Evidence ET-2: Measurements and Analysis Regarding Proposed Access E

LAND AT ELMSBROOK, BICESTER: PROPOSED RESIDENTIAL DEVELOPMENT

Planning Inspectorate Ref.No. APP/C3105/W/23/3315849

Cherwell District Council Application No. 21/01630/OUT

Figure 1: NW corner of Eastern Parcel, showing proposed Access E entrance, and the potential Visibility Splay encroachment identified and marked by VTP, to the left side of this.

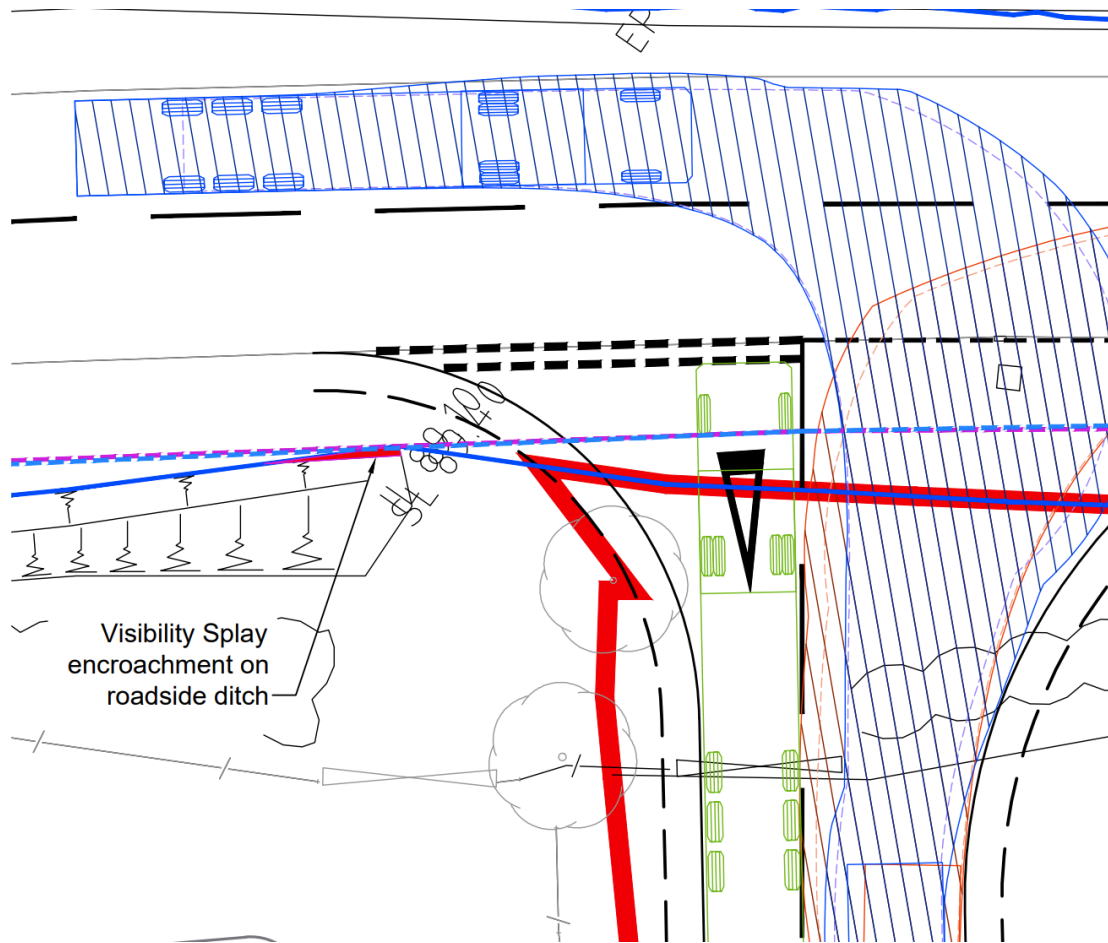
- 2.1 Regarding point 1.6 regarding visibility splay encroachment: discussion with independent Highways Consultant D. M. Mason identified that the drain could represent the corner of third-party owned land, and thus be used as a “ransom strip” – which would make the build non-viable. The location of the drain was identified to be at the end of a roadside ditch area, as shown in Figure 1, which is taken from VTP’s proposed Access E design drawing (“4600-1100-T-011 RevF-Site Access E-Construc E Parcel.pdf”).

- 2.11 For all 4 of the above drawings, there is a technical error regarding the visibility splays: these should have been drawn back to the *midpoint* of the drain, as opposed to the corner. However, given the A2Dominion clause noted in 2.8, it could have been drawn back even further (though based on the angles involved, it would not require this).

- 2.12 **Conclusion #3:** On all 4 of the drawings listed in 2.10, the highway boundaries are drawn in the wrong place, and the visibility splays are drawn incorrectly; the points referenced as ‘Visibility Splay encroachment on roadside ditch’ and ‘Point of highway boundary that cant [sic] be crossed with visibility splay’ (in all caps) are both incorrect to state so. A clear visibility splay of 120 metres to kerb-side is fully achievable, and thus Access E is viable.

Figure 2 (a): Aerial View of area/drain, from Google Maps

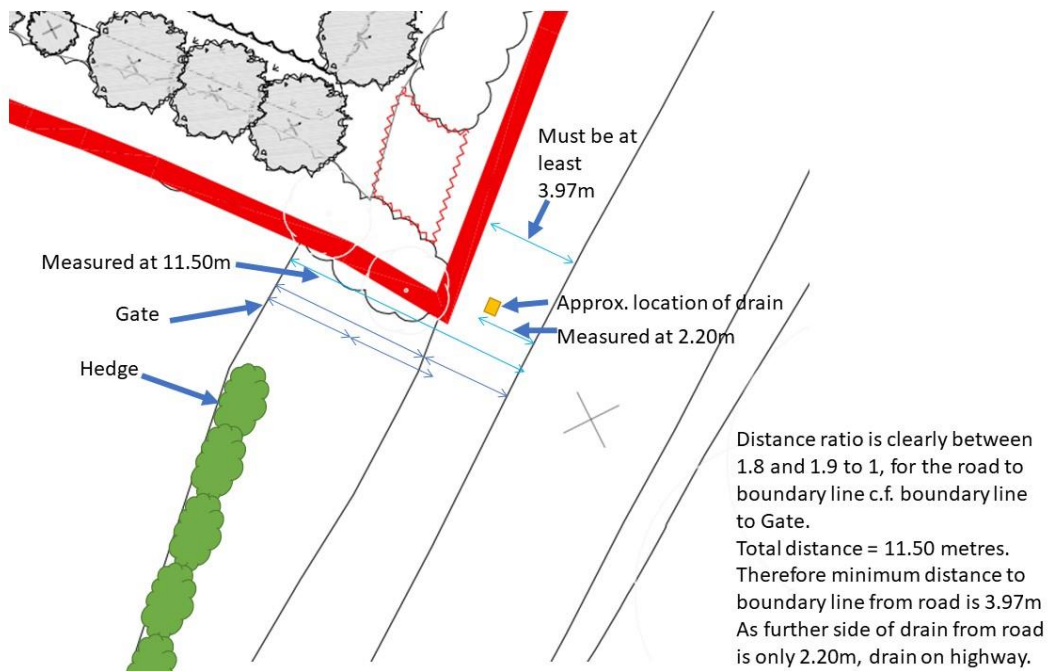
- 2.4 Very simple measurements were undertaken with a measuring tape, at and just beyond the corner of the Eastern Parcel immediately adjacent to the B4100 Banbury Road. These were followed by simple calculations. Figures 2(a) and 2(b) below show overlays of the measurement results and calculation information onto: 2(a) a Google Maps aerial view of the location; and 2(b) from the North field site plan 03_006C, from 10/01780/HYBRID.

2.5 Tape measurement from the road to the gate found this distance to be 11.50 metres. From comparison of the arrows on Figure 2(b), the ratio of the road-to-A2-boundary (red line at this corner, giving a conservative underestimate) to the A2-boundary-to-Gate distances is 1.9:1. This means that the A2 boundary must be at least 3.97 metres from the road; from approximate measurement (a ditch centre is not a clear boundary) it is actually likely to be more 4.0 metres at the defined "corner", and increases heading west along the B4100.

- 2.6 The drain(s) lie within 2.20 metres of the road edge (as shown in Figure 7), which is within the minimum required 2.50 metre width of verge within the highway boundary. It seems clear that, as is common by Riparian ownership at a field boundary, A2Dominion owns up to the middle of the ditch. By measurement and calculation, the corner of the A2Dominion land is at least 4.0 metres from the roadside (at the nearest point).

- 2.7 **Conclusion #1:** This means that the drains and surrounding area lie *outside* of A2Dominion land: the area of up to 4.0 metres at the corner has been adopted by Oxfordshire County Council, as the local council with Highway Authority, as part of the highway boundary.

Figure 3: Taken from the Home Farm access Planning Permission 01/01836/LB, from drawing OP4/a by Roger N Cross Services.

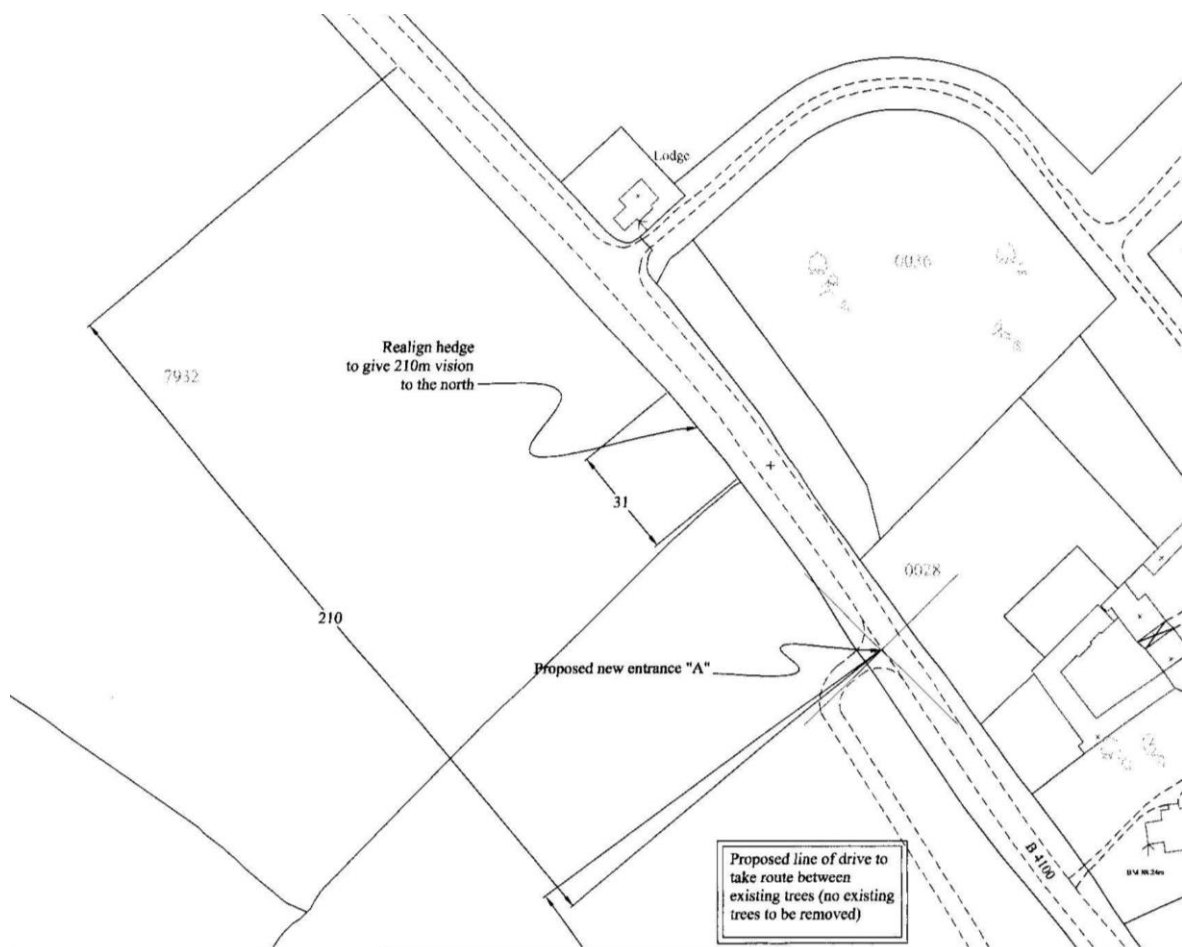
- 2.15 **Conclusion #5:** There is nothing to obstruct an accurately drawn visibility splay going over the area surrounding this drain. Referring back to the drawings for the original Home Farm access permission, granted in 2001 – see Figure 3 – it was found that 210 metres visibility each way is possible there, provided 31 metres of hedge to the north was realigned (NB: the hedge here needs trimming back, which is a triviality; the splay is still there).
- 2.16 Since the proposed Access E entrance sits *within the western 210 m splay*, and is located almost exactly 50 metres from the Home Farm entrance, this means that in theory a visibility splay of 160 metres is possible – more than required for the 120 metres for the 40 mph speed limit.
